November 18, 2014

**RE: Addendum to the Contract Documents for the Geddes Dam - Tainter Gate #4 Replacement project.  
Bid No. ITB-4356**

**ADDENDUM NO. 1  
TO  
BID DOCUMENTS  
FOR  
GEDDES DAM – TAINTER GATE #4 REPLACEMENT  
FOR THE  
CITY OF ANN ARBOR, MICHIGAN**

8 NEW SILL  
S302 1"=1'-0"

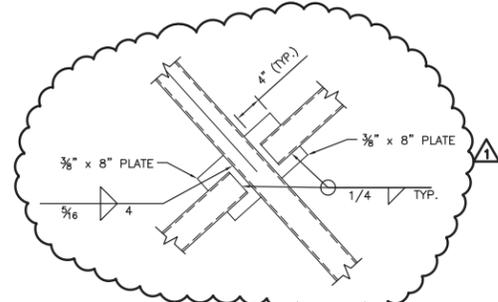
Q: Will the weld on detail 8/S302, attaching the SS leveling studs to existing weld plate, be subject to weld testing?

Q: Will the weld on detail 8/S302, attaching the SS leveling plate to the side seals, be subject to weld testing?

A: No.

A: Yes.

3 TRUNNION PIN INSTALLATION  
S303 3/4"=1'-0"

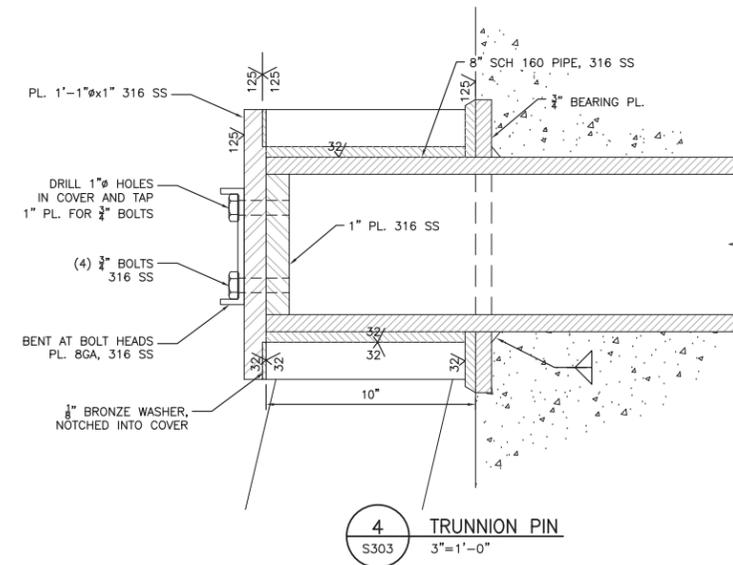
Q: Will the weld on detail 3/S303, connecting new pin to old, be subject to weld testing?

A: Yes.
